Board of Architectural Review

DATE: May 15, 2015
TO: Board of Architectural Review Chair and Members
THROUGH: Jason Sutphin, Community Development Division Chief *JBS*
FROM: Kelly O'Brien, AICP, BAR Liaison *KO*
SUBJECT: **3168 Campbell Dr – The Lamb Center**

1. Case Number: 15040095
2. Address: 3168 Campbell Drive
3. Request: Construction of new two-story building and site improvements
4. Applicant: The Lamb Center
5. Applicant's Representative: John MacPherson
6. Zoning: I-2 Industrial District

WEST ELEVATION (N/A/N)

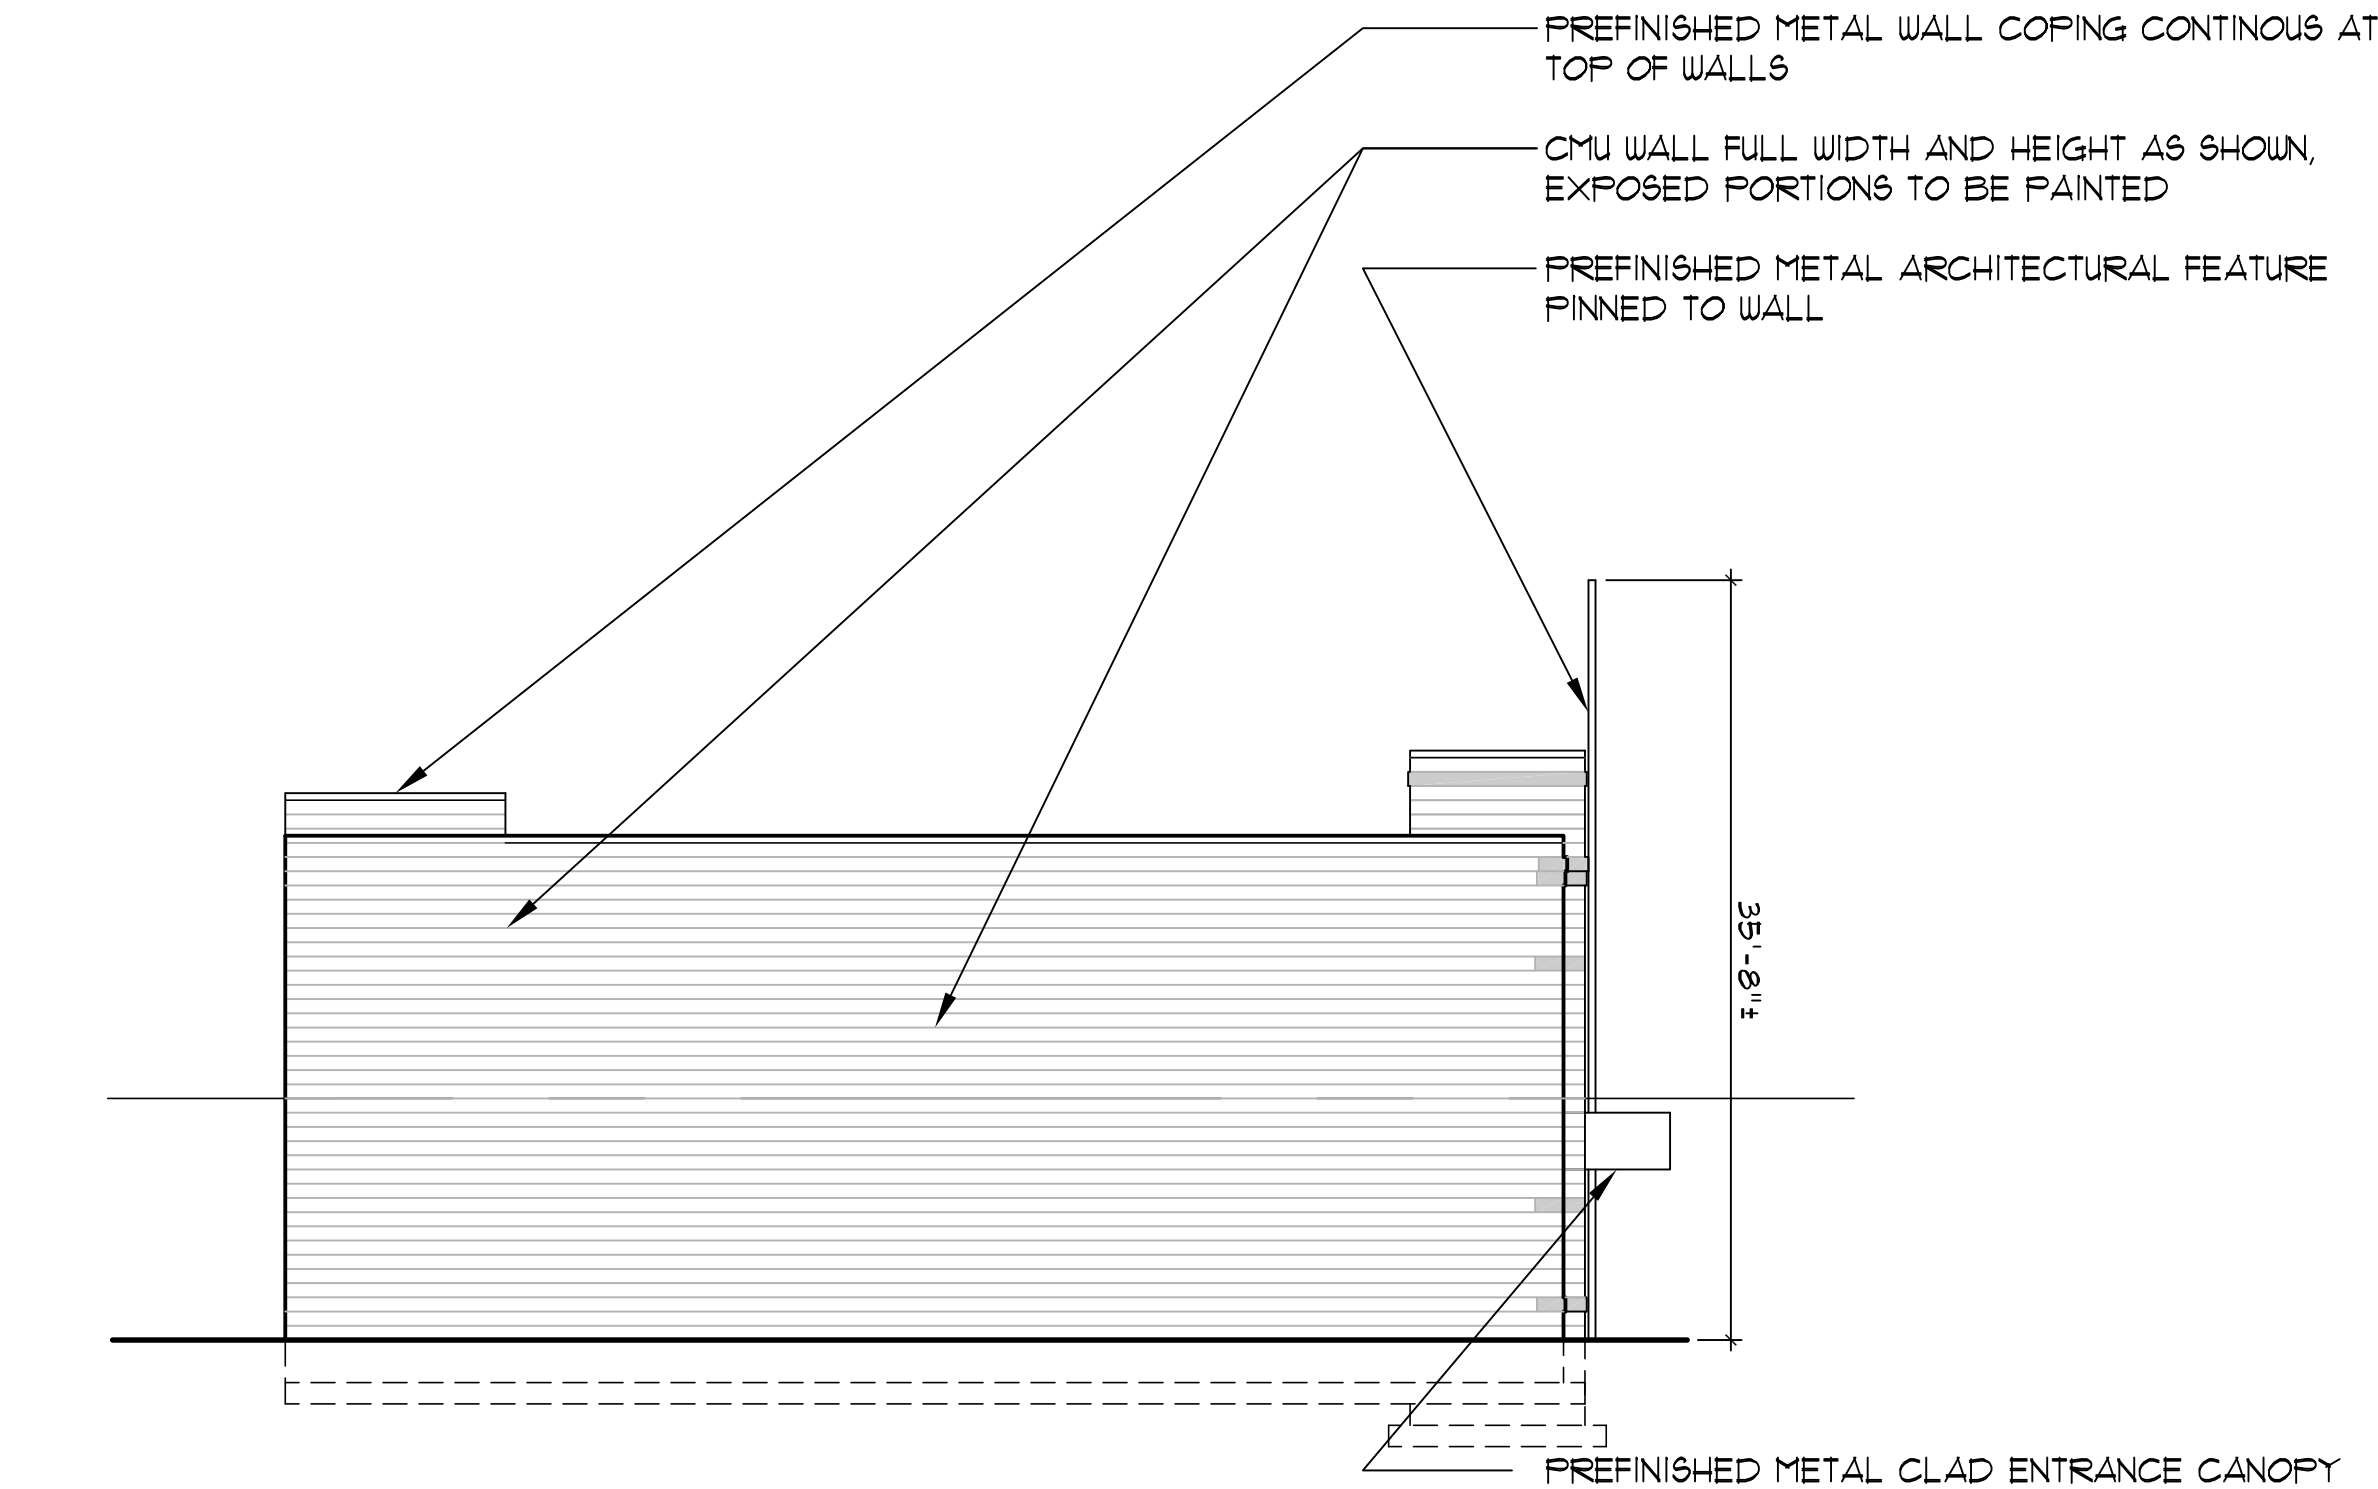
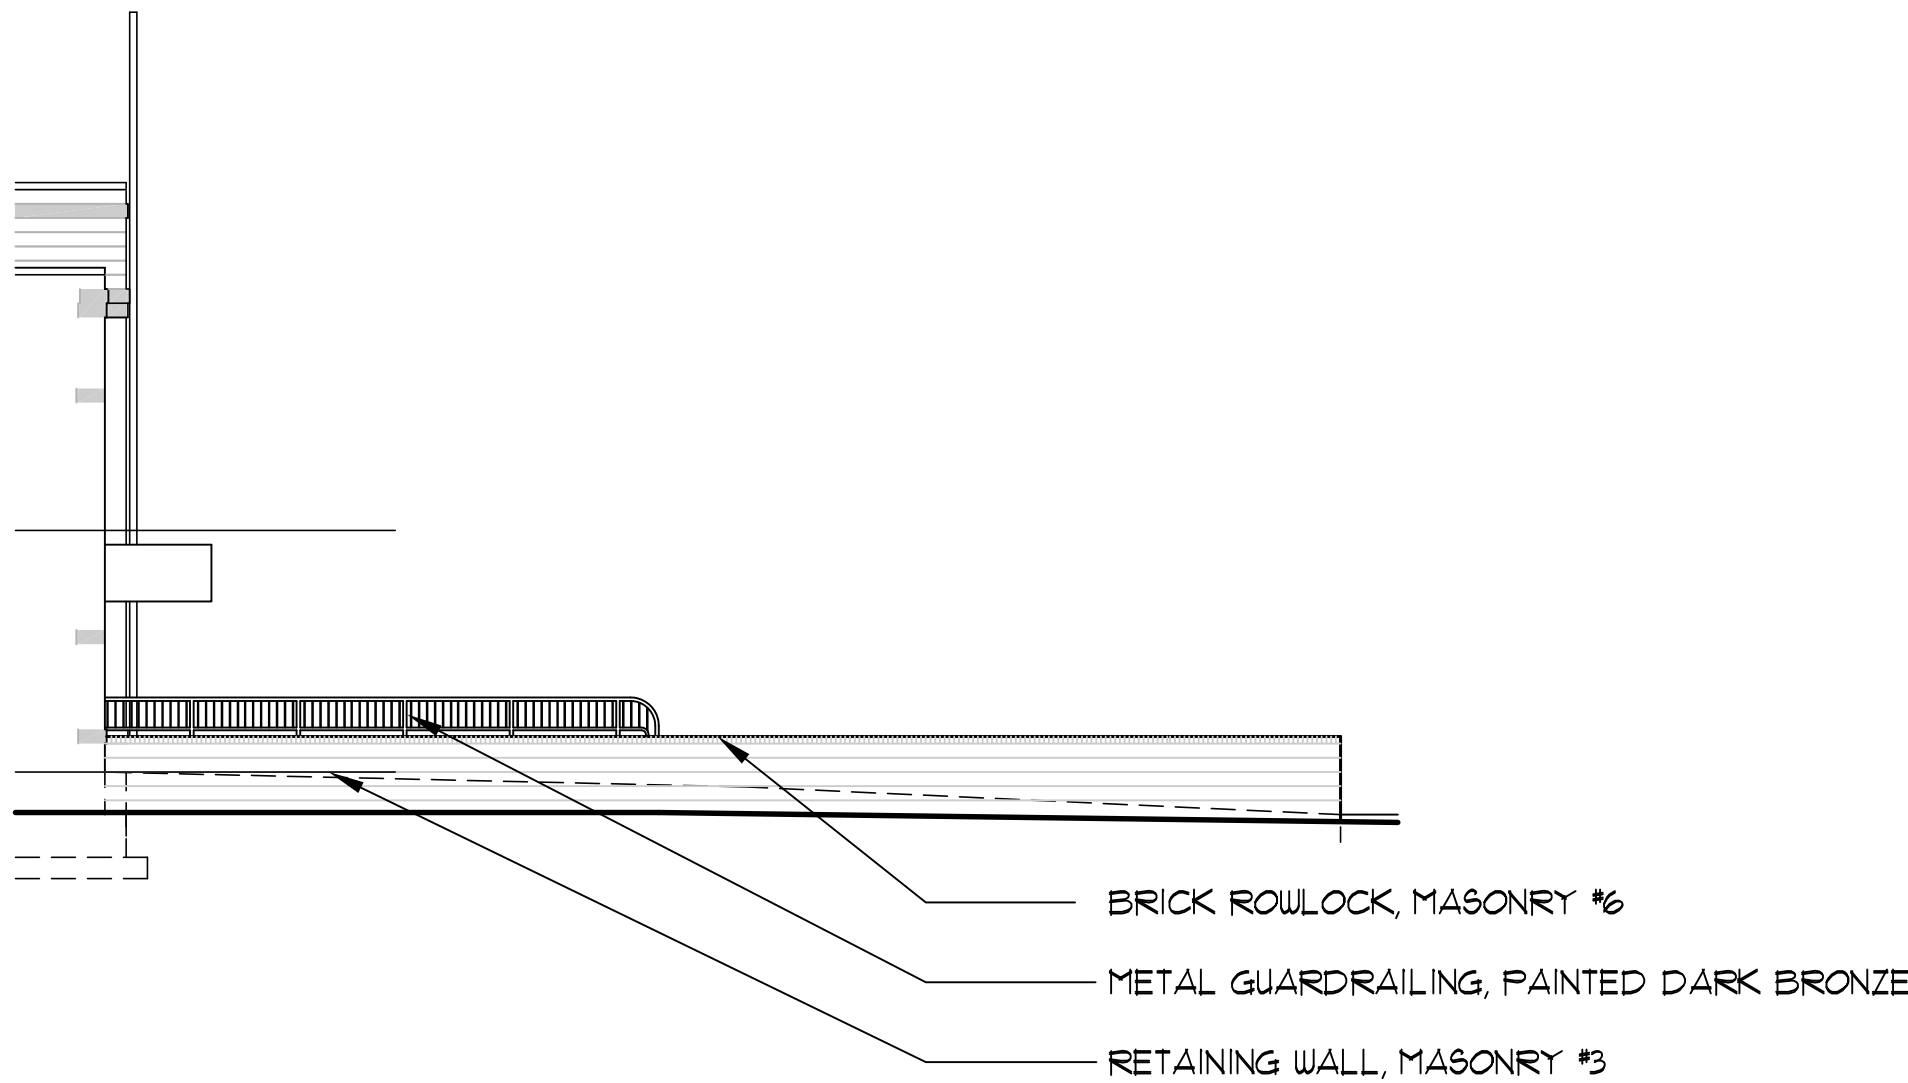
The decorative mix of masonry textures is proposed only for the front east façade and north façade. The rear west façade will be built 0.6' from the property line, within a few feet of the existing parking deck on the adjacent property, and the south façade will be built 0.8' from the property line, within a few feet of the existing building on the adjacent property. Because these two facades will be obscured by the adjacent buildings, the applicant is proposing to use CMU block for both faces.

The east and north facades consist of a mix of bands of different shades and textures of masonry. The base of the building is proposed as Betco Supreme 'Goldenrod' split face block, then a band of 'Dark Chocolate', a section of Glen Gery Tuscan Series 'Golden Dawn', a band of 'Dark Chocolate', 'Limestone' for the middle section, a band of 'Dark Chocolate', another section of 'Golden Dawn', topped off with single bands of 'Pearl Mist', 'Dark Chocolate' and 'Limestone' in that order. Metal coping is proposed for the top of the walls. Colored mortar AMX-407 and AMX-501 are proposed. The applicant's renderings depict the sections of 'Golden Dawn' and 'Limestone' as similar in shade, however, staff feels the color differentiation would be much more pronounced than shown.

DUMPSTER ENCLOSURE

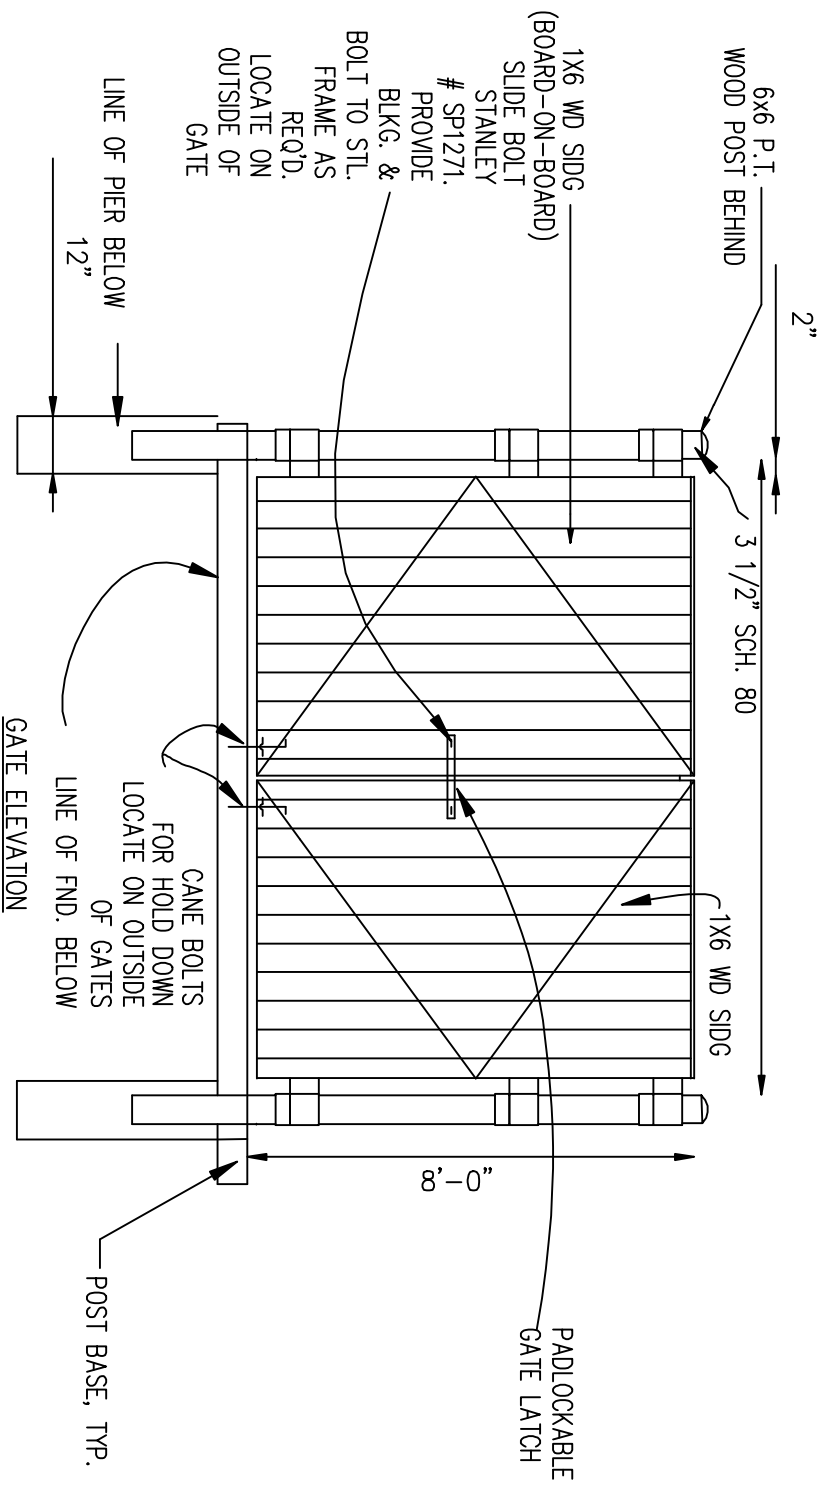
The dumpster enclosure uses the same masonry as the building with a board on board double gate. The detail does not specify if the gate will be left untreated, stained or painted. The police department has safety concerns relating to the obscured area behind the dumpster. Staff recommends the applicant work with Police and Fire to rectify the issue prior to any site plan approvals or permits being issued.
